FISH PASSAGE CENTER

MEMORANDUM

RE: FCRPS Juvenile Performance Standard and Metrics

In response to your request, the FPC staff reviewed the Draft document entitled, "Federal Columbia River Power System Juvenile Dam Passage Performance Standard and Metrics", (the document) dated January 2012. The document summarizes the Biological Opinion performance standard language and describes the "Virtual Paired Release" study design utilized at The Dalles, John Day and Bonneville dams. The objective of the document is to describe the basis of decisions, establishing a decision framework for specific hydroelectric project operations such as spill level. The document states that these decisions will be based upon 1) the results of the Virtual Paired release studies and, 2) on past studies according to criteria identified in Appendix B. A Decision Framework, as described in the scientific literature, is defined as a method of organizing and evaluating information, leading eventually to the making of a decision. The subject document proposes to base the decision of hydroelectric project operations entirely on a single source of information, either the results of virtual paired release acoustic

Lower Granite to McNary 1998-2011 juvenile reach survival versus annual spill percentage

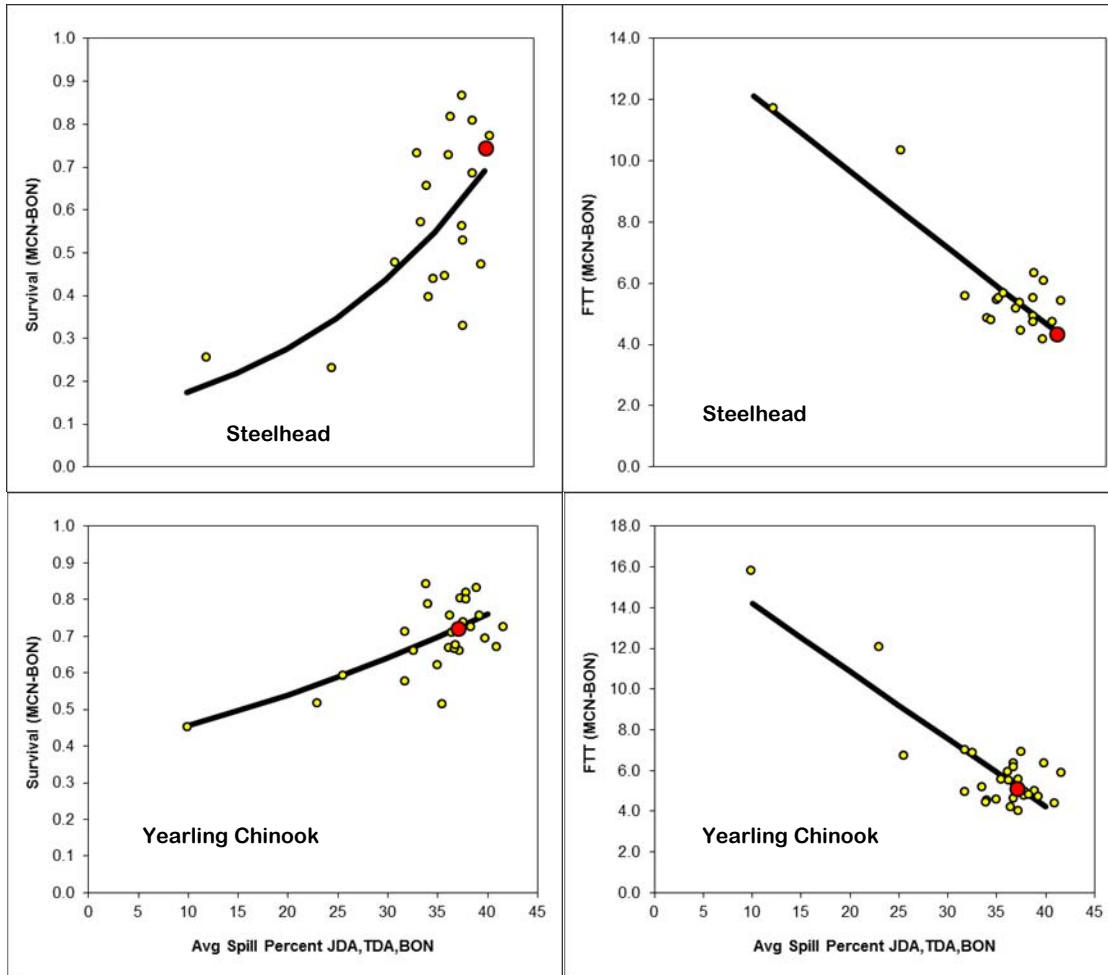
Faulkner et al. (2010) concluded that, despite relatively lower flows and water velocities in 2010, yearling Chinook salmon and steelhead migration rates through the hydropower system were near average, and faster (i.e., travel times shorter) than those in years with similar levels of flow. Relatively high spill proportions and the use of surface collectors at most projects likely helped compensate for the lower water velocities by shortening fish travel times. The following figures show the relationship of project spill level to reach survival and fish travel time.

Establishing at project spill levels on the basis of “at concrete” project survival estimates as proposed in the document, does not incorporate or address new knowledge regarding the delayed effects of hydroelectric project operations, and the wide range of life cycle benefits resulting from higher spill levels. In addition establishing project spill levels as proposed in the document only provides partial mitigation for the impacts of specific hydroelectric project operations.
